SUNDRY NOTICES AND REPORTS ON WELLS

Dunn Federal #4

30-015-01822

OXY USA Inc. - Proposed
Dunn Federal #4
API No. 30-015-01822

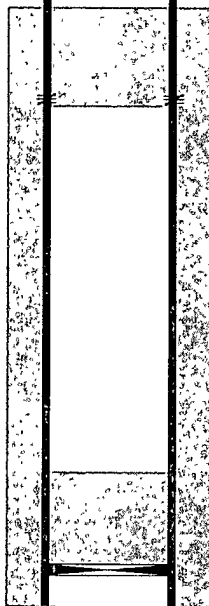
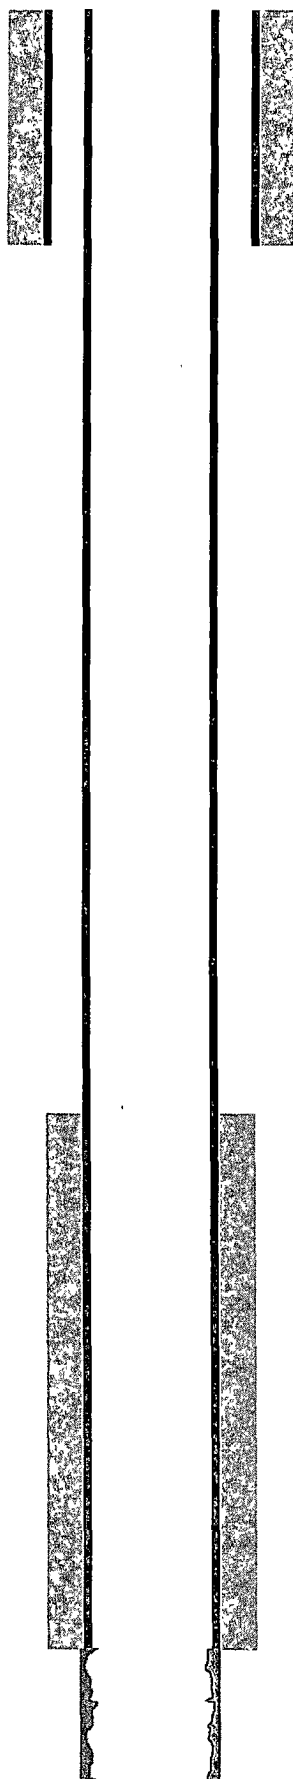
③ Perforate @ 700' SDZ to
Surface

② Perforate @ 1845' SDZ to 1725'

Cap w/ 30 SK CMT

① Set CIBA @ 2340
